DESIGN ADVISORY BOARD Tuesday May 10, 2016 at 3:00 PM Conference Room 12, City Hall, Burlington, VT Agenda

TO: Design Advisory Board
FROM: Scott Gustin *AD*
DATE: May 10, 2016
RE: 16-1145CA/MA, 207 Flynn Avenue

Request: Construct new retail grocery building and related site improvements and subdivide lot.

LAYOUT PLAN

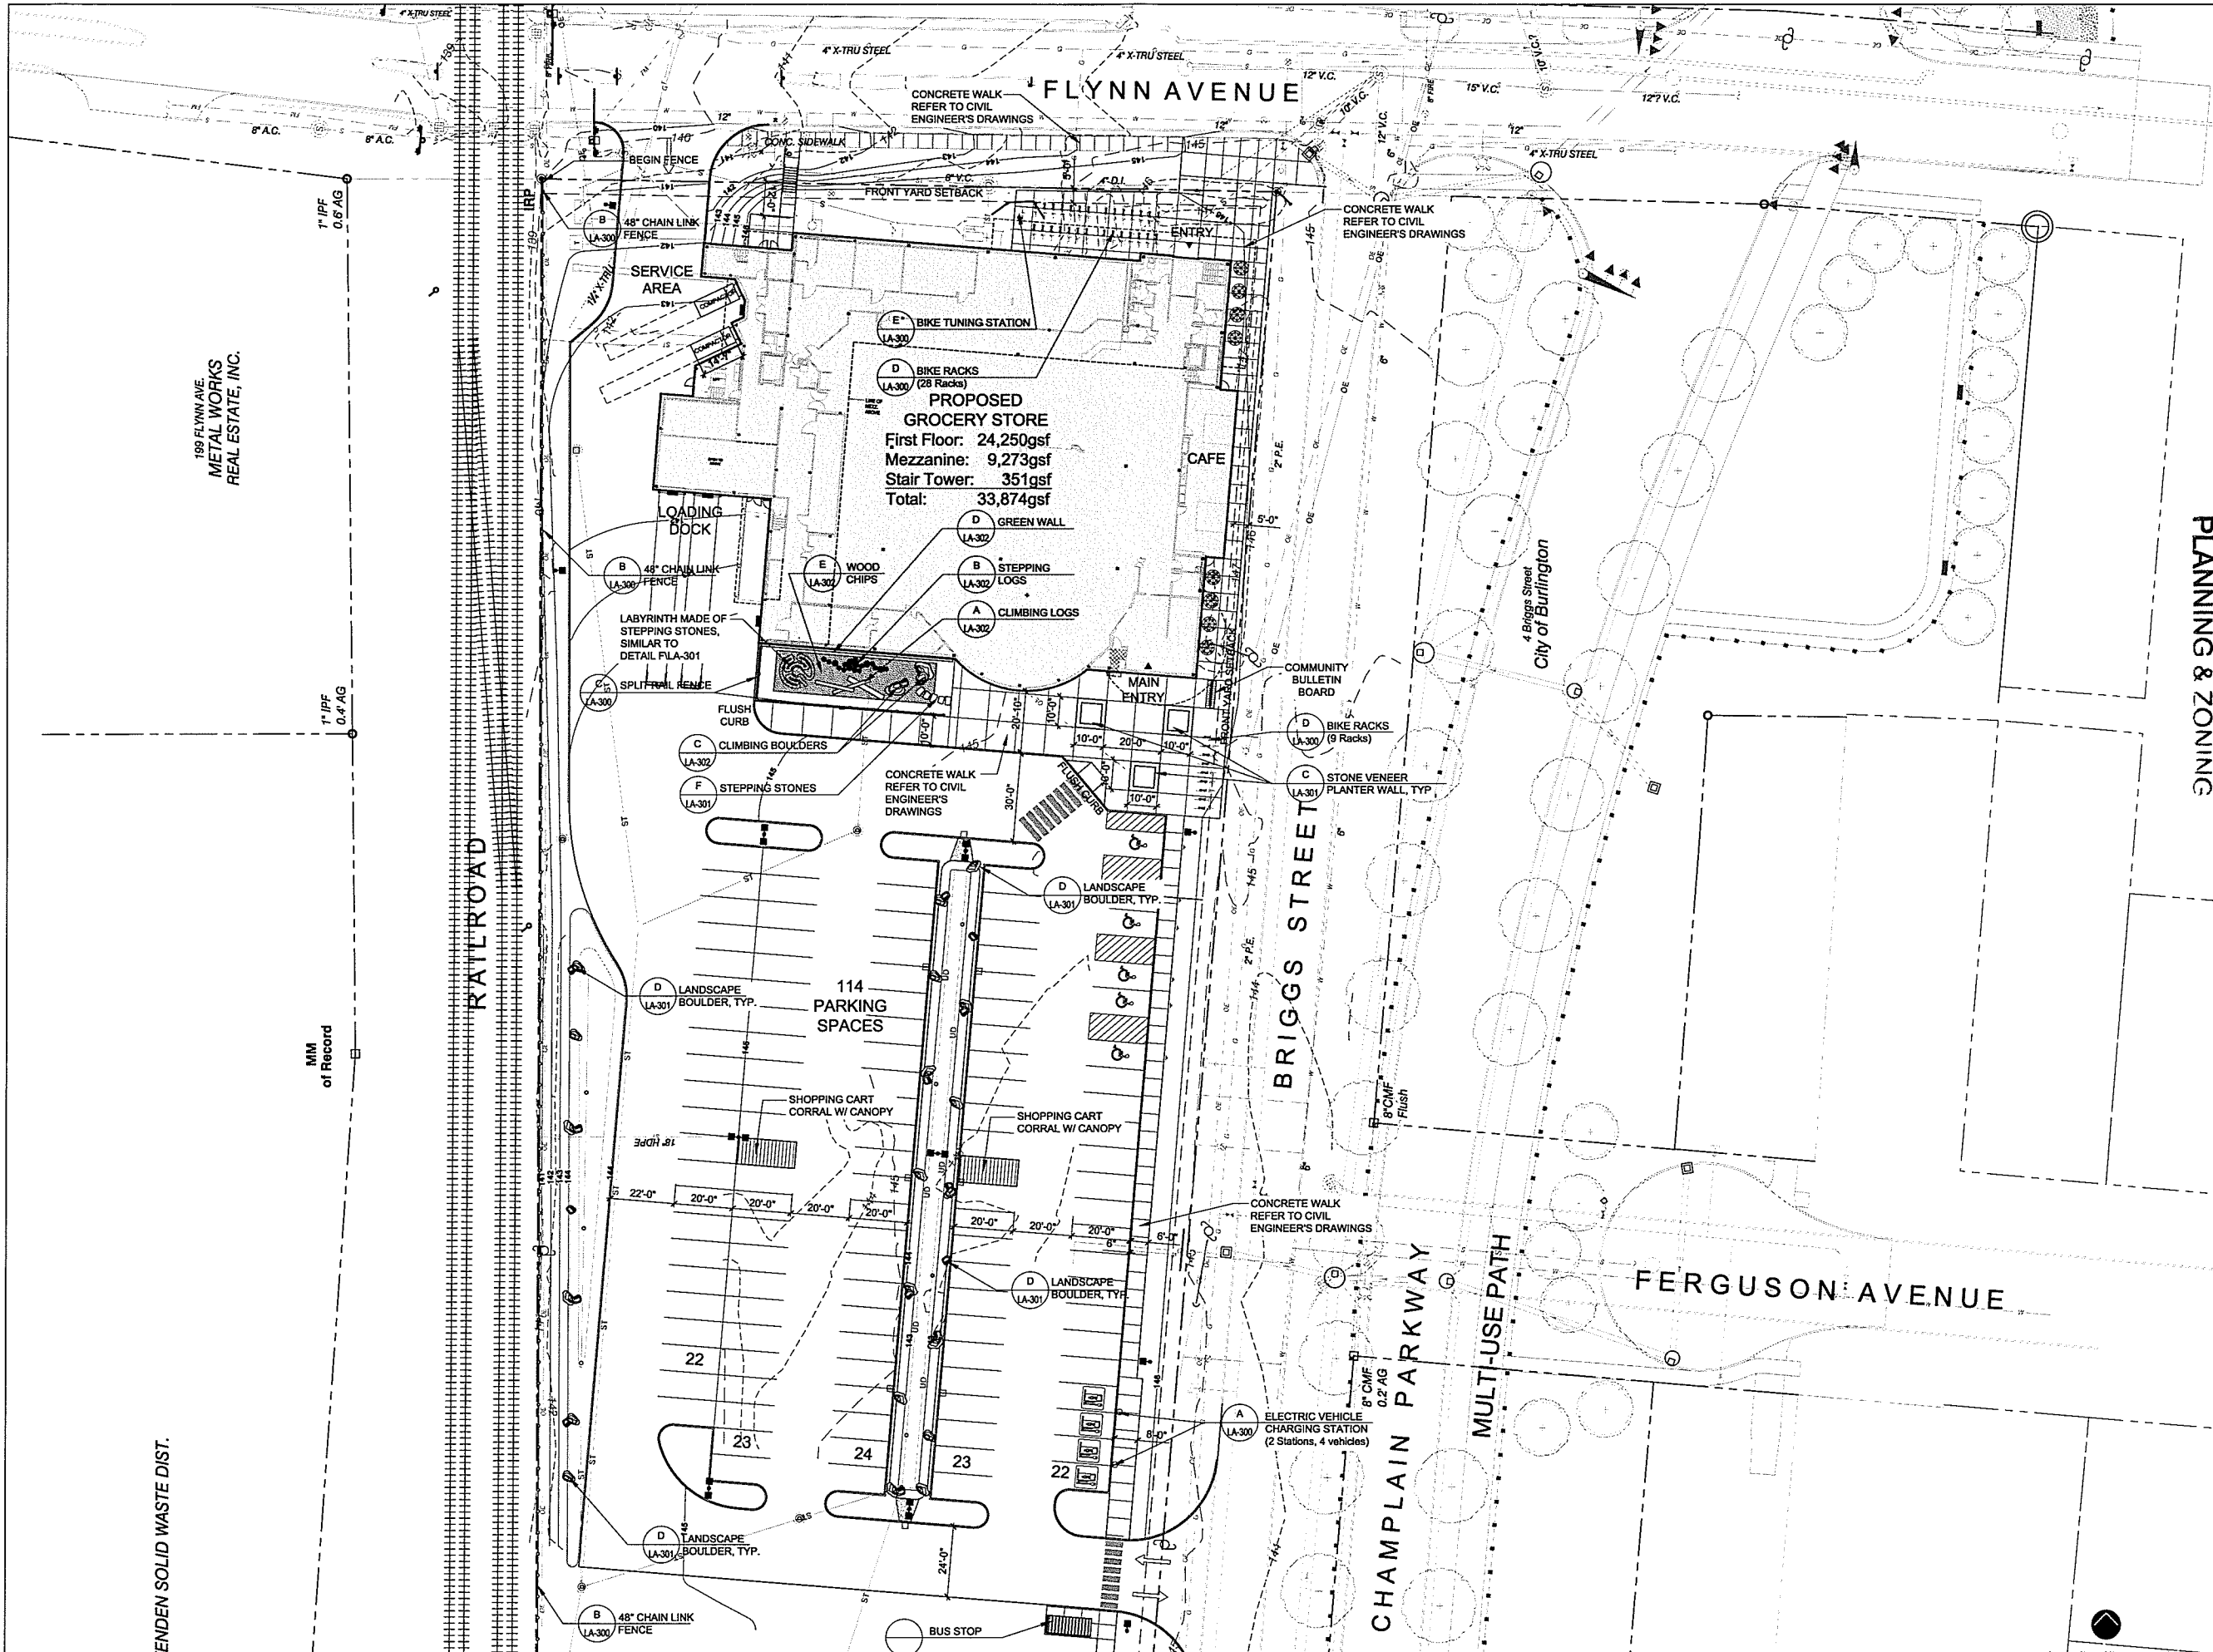
The Briggs Street driveway is 24' wide, sufficient to allow simultaneous in-and-out movement under the vehicular circulation standards of Article 8. The Flynn Avenue driveway is 30' wide, and appears to be as wide to afford access to the loading bays on the building's west side. If possible to lessen the width of this driveway, the applicant is encouraged to do so.

Walkways and related hardscaping afford direct pedestrian access into the building from the public sidewalk. Interior pedestrian routes within the parking area are lacking. This criterion requires provision of safe, well-defined pedestrian routes through parking areas to primary building entries. Only one such route, along the eastern edge of the parking area, is provided. No pedestrian routes are provided to connect the two double-stacked rows of parking to the building's main entry. Plan revisions are needed in order to provide such routes. Lastly, striping is depicted across the Briggs Street driveway to delineate pedestrian crossing continuous with the proposed walkway along the eastern edge of the property. No such delineation is depicted across the Flynn Avenue driveway. This arrangement may be acceptable because there is no public sidewalk further west along Flynn Avenue. Note that this section of sidewalk along Flynn Avenue will be constructed as part of this project. Construction of this sidewalk is subject to review and approval by the Department of Public Works.

Parking spaces and circulation isles appear to be dimensionally compliant. Parking spaces are 9' X 20', and circulation isles are 20' wide allowing for 10' wide travel lanes. Back-up distance is slightly substandard at 20', whereas 24' is the standard for 90-degree spaces. Some variation from this standard is permissible per Sec. 8.1.11, *Parking Dimensional Requirements*.

Curbing is proposed along the eastern and northern ends of the parking area. None is evident along the western or southern ends. Landscaping along the periphery also serves to delineate the boundaries of the parking and circulation areas.

The proposed parking lot will require shade trees. No parking lot shading analysis is included in the application and must be. This criterion establishes a target of 30% shading of the parking area with new shade trees. At least 1 shade tree for every 5 parking spaces is required. The new parking lot will contain 114 parking spaces and will require 23 shade trees. As proposed, 29 new trees will be planted within or around the parking lot. Minimum caliper size at the time of planting must be 2.5" – 3.5." As proposed, caliper size is compliant. A mature canopy diameter of at least 25' is needed. No canopy diameter information is evident and must be provided.

1. Lessen the width of the Flynn Avenue driveway if feasible.
2. Provide safe, well-defined pedestrian routes through both double-stacked rows of parking for access to the main building entry.

3. Provide landscaping island(s) within the westernmost double-stacked row of parking.
4. Provide a parking lot shading analysis demonstrating at least 30% parking lot shading. Also provide anticipated mature tree canopy dimensions.

LIGHTING PLAN

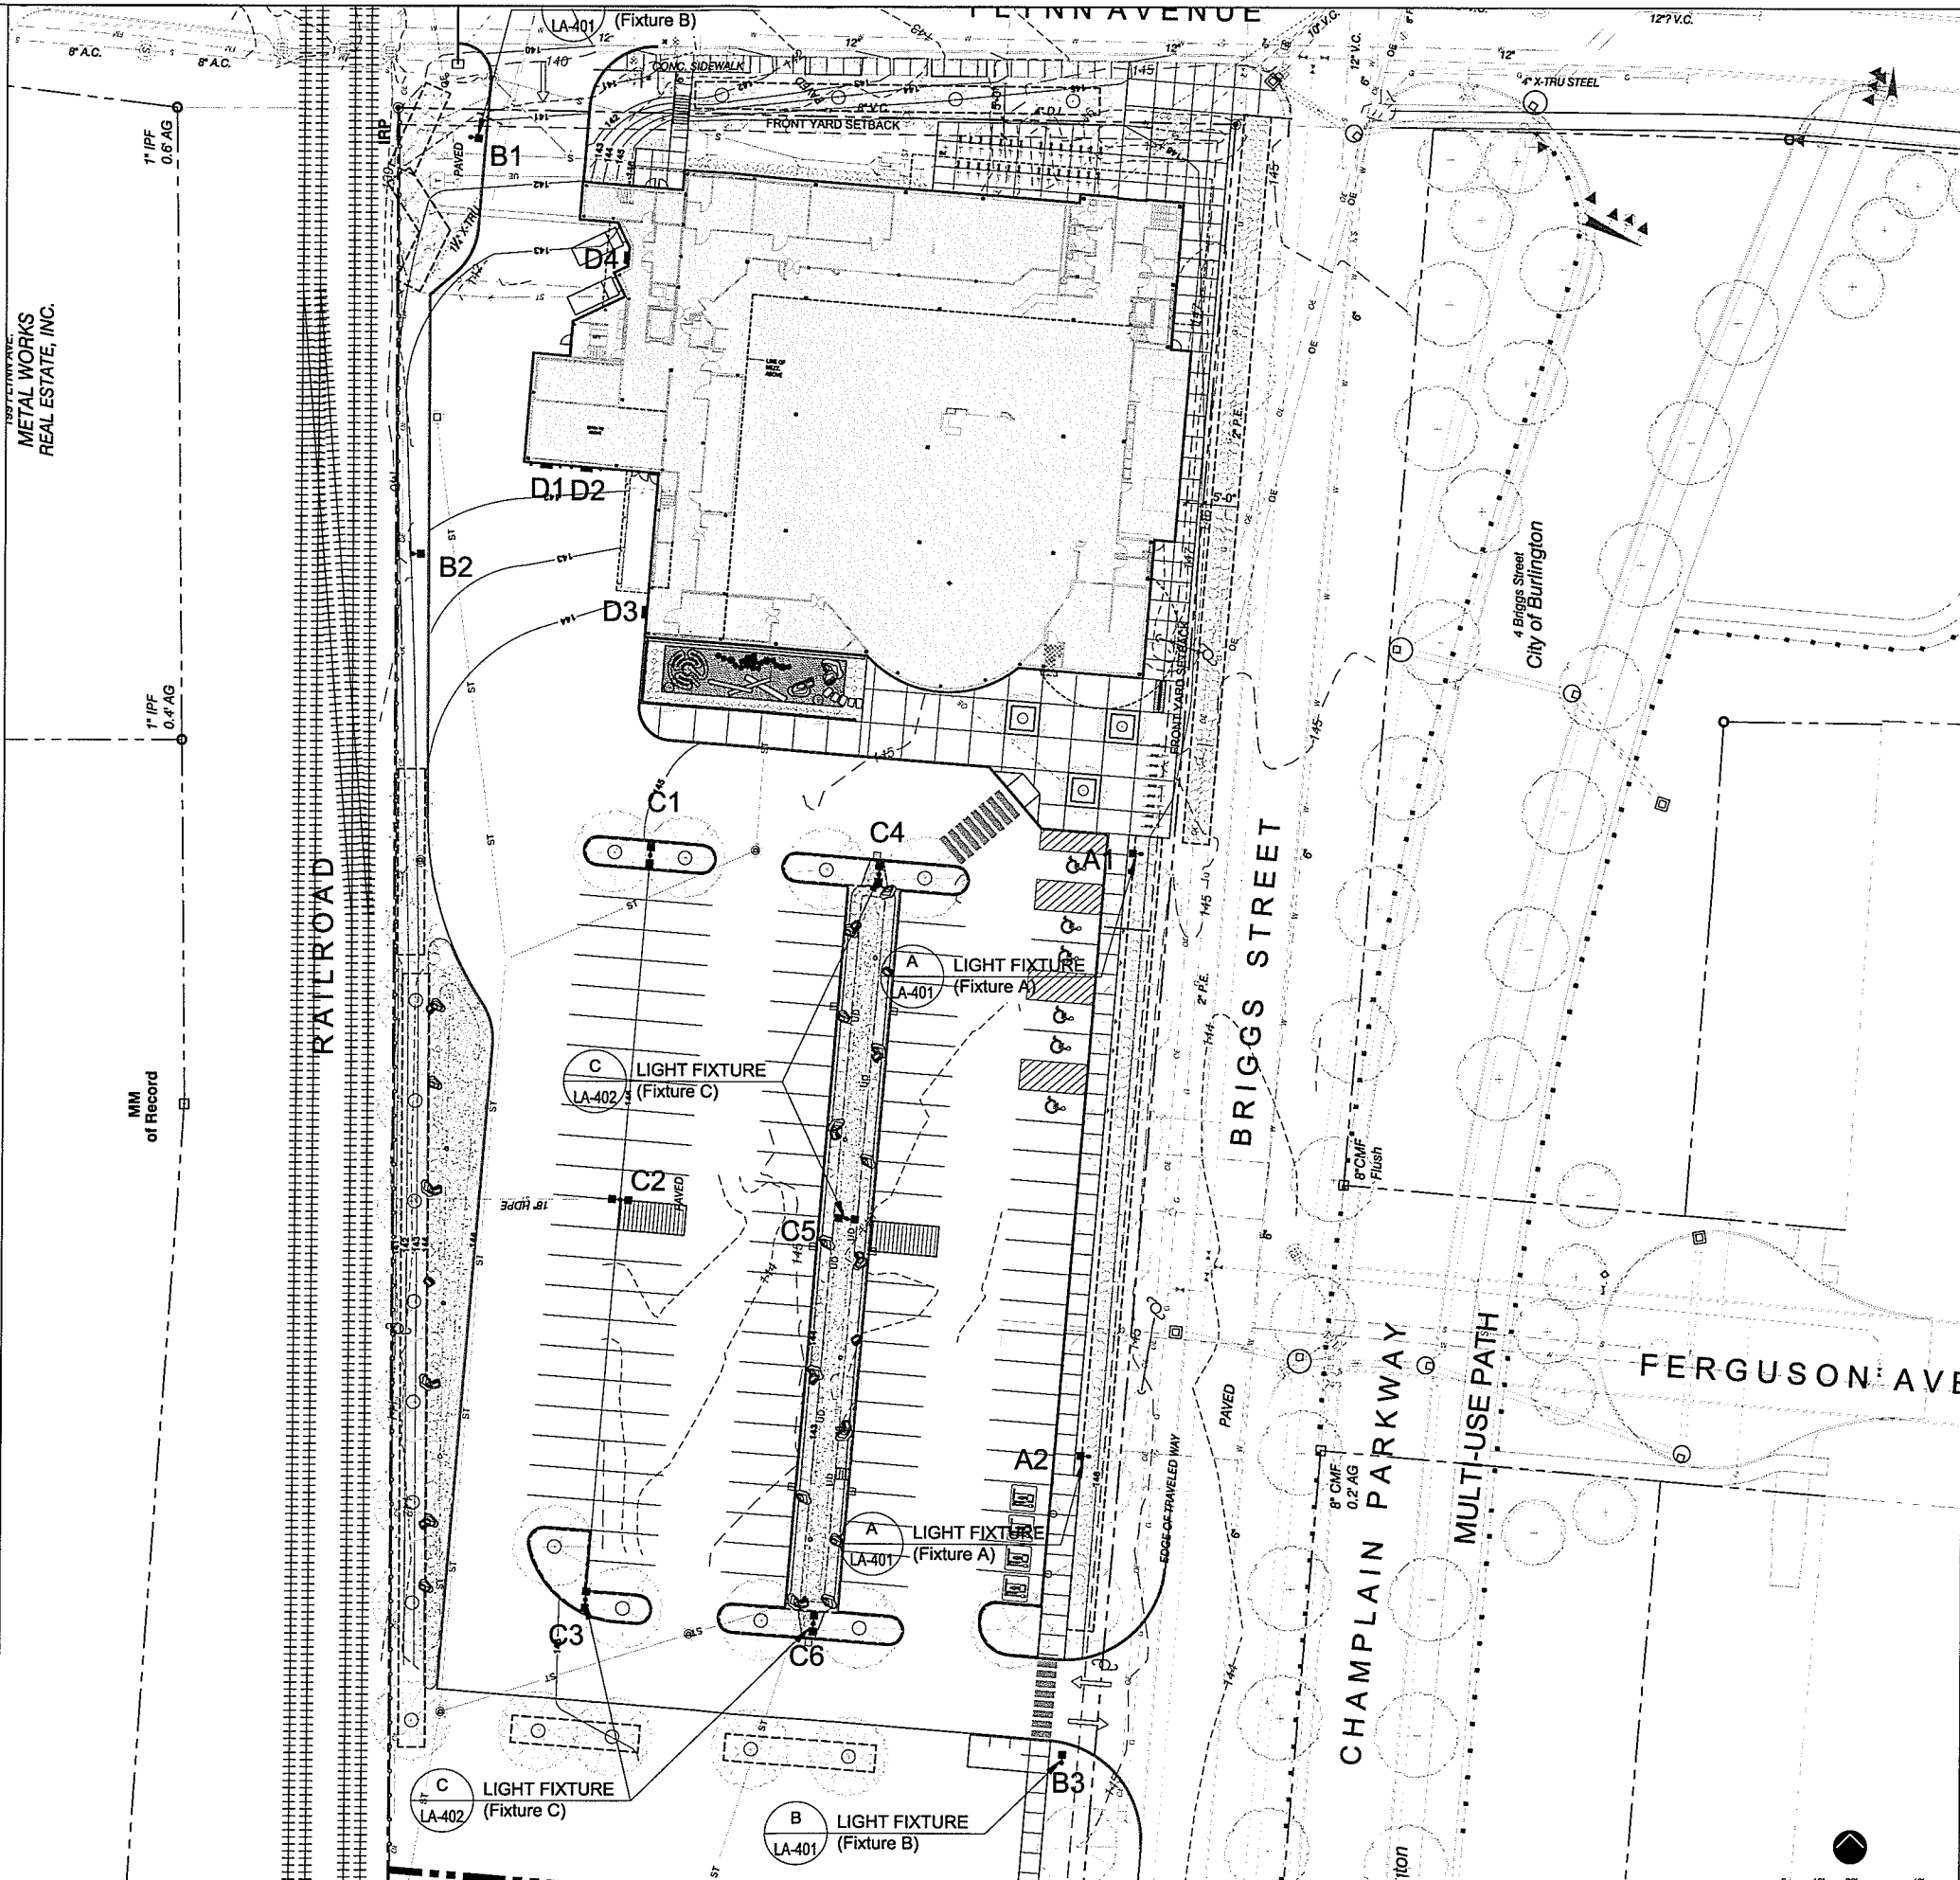
An outdoor lighting plan has been provided. Fixture locations are noted within the parking and circulation areas and for the loading bays. No fixtures are indicated for the building's pedestrian entries. Presumably, these entries will be illuminated. Fixture specifications and locations are needed. Details are provided for the parking lot lights. They are acceptable cutoff LED fixtures mounted at 20'. No depiction of the proposed wall sconce for the loading bays is evident and must be provided. Finally, no photometric plan has been provided. One is needed in order to demonstrate compliance with the illumination standards for the building entries and parking and circulation areas.

5. Provide building entry lighting fixture locations and specifications. Provide depiction of proposed wall sconce over loading bays. Provide a photometric plan that includes a point-by-point photometric analysis of proposed illumination levels. Average, minimum, and maximum illumination levels must be summarized in a table for each lighting environment (i.e. parking/circulation and building entries).

ROOF PLAN

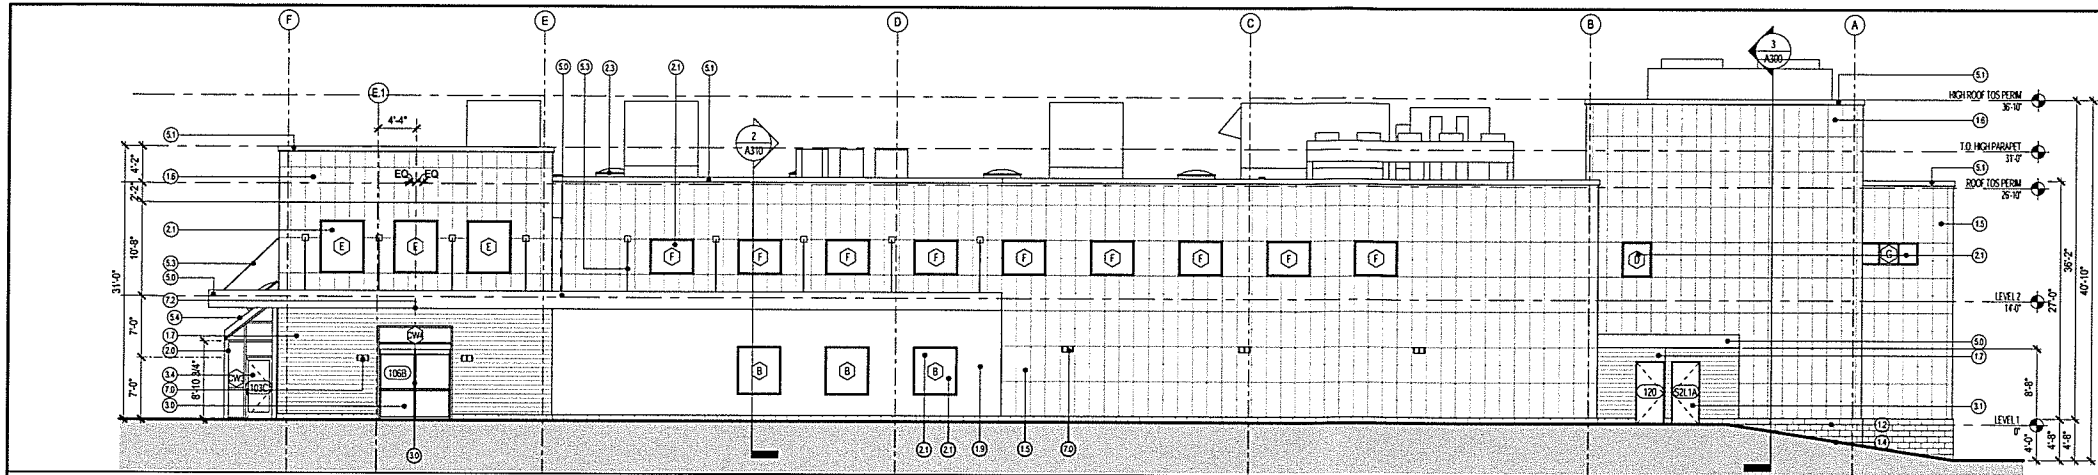
Loading bays are screened from the street and are set apart from active pedestrian areas of the site. Abundant rooftop mechanicals are proposed, some of which are quite large. This criterion requires screening such features within the overall roof structure, outer building walls or parapets, or integrated into the overall building design. No such screening is proposed and is required. Note also that some of the proposed equipment is tall enough to exceed the overall 45’ height limit. The total area of such features cannot exceed 10% of the roof area. Confirmation is needed as to whether this limitation has been observed.

6. Provide additional pedestrian activation of the Flynn Avenue façade.
7. Provide screening for all rooftop mechanicals and confirm whether mechanical units exceeding the overall 45’ height limit comprise 10% or less of the total rooftop area.
